COMMUNITY DEVELOPMENT DEPARTMENT

PRE-APPLICATION CONFERENCE NOTES iQ Credit Union - Site Plan (PLZ-23-0022)

PROPOSED SITE PLAN

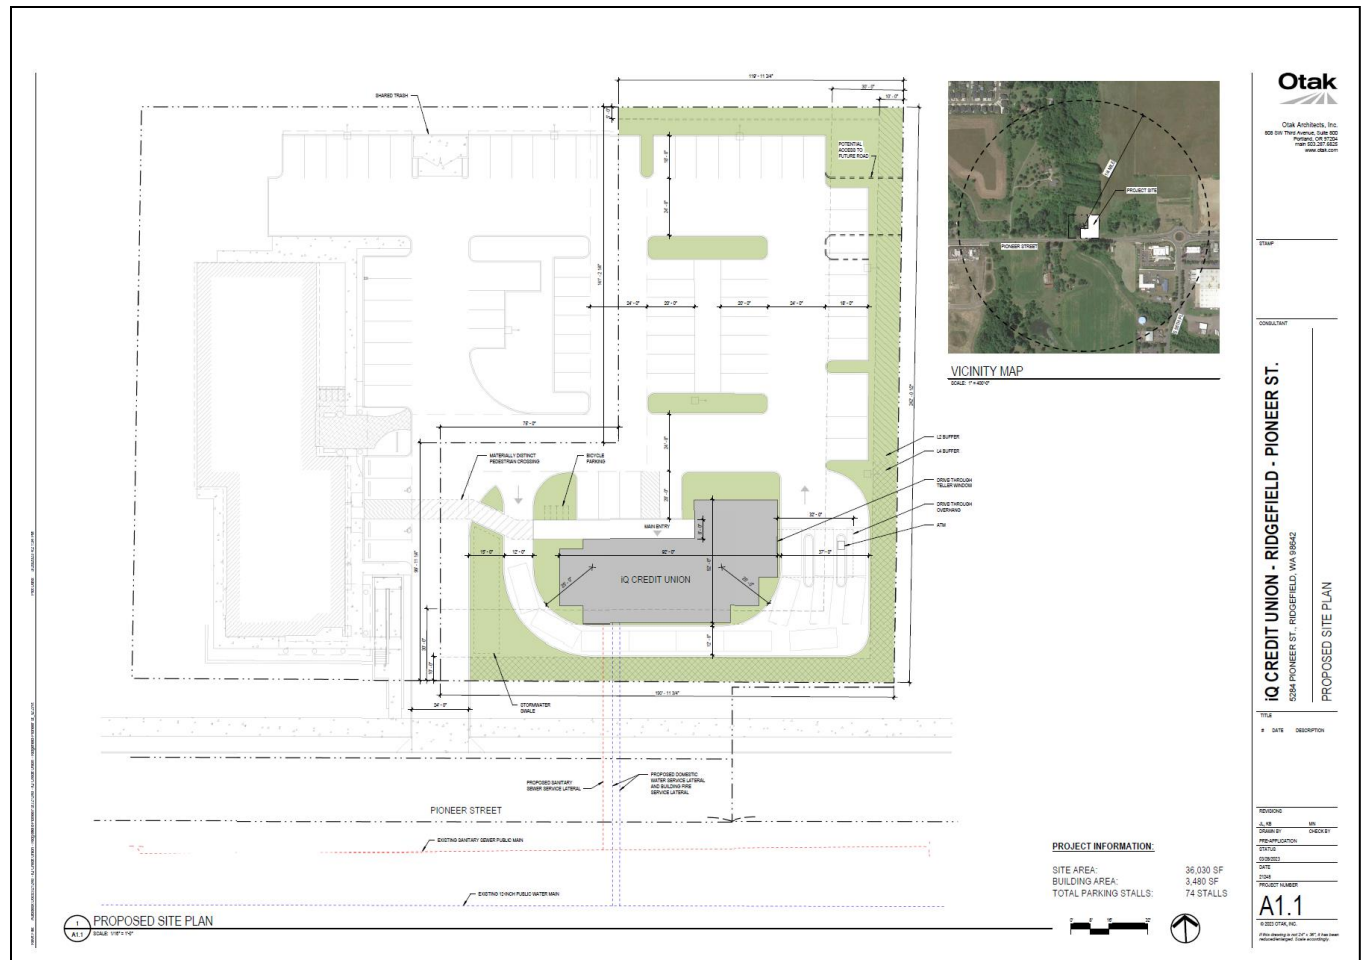
General site observations and reactions to the proposal include:

- Applications Required.
 - Basic Site Plan application is required. [RDC 18.500](#). This is a Type II application that will require public notice, SEPA analysis, a 21-day comment period, and an administrative decision – subject to appeal.
 - A Critical Areas. Permit is also required if the project will impact wetlands, riparian areas or their buffers located on site or from impacts to buffers of off-site critical area which extend into the site. Riparian habitat buffers are present off-site. The property is in Critical Aquifer Recharge Area II (CARA).
 - SEPA Checklist. A SEPA checklist is required because of the intensity of the proposed new use and the scale of the development.
- Archaeological Review. Moderate – high predictive model. An archaeological reconnaissance study is required.

- Frontage Improvements. Pioneer Street dedication and improvements are required. Coordinate with Engineering regarding the timing of the City-sponsored frontage improvements.

- Stormwater Management. Please provide a technical stormwater management report. Stormwater design regulations vest at the time of final engineering review not at land use approval.

- Transportation. A transportation impact analysis (TIA) is required because the proposal will generate more than ten peak hour trips.
- Erosion Control. The City will require compliance with its erosion control standards to reduce erosion potential and stream sedimentation during all phases of construction. Please contact the City Engineer for assistance.
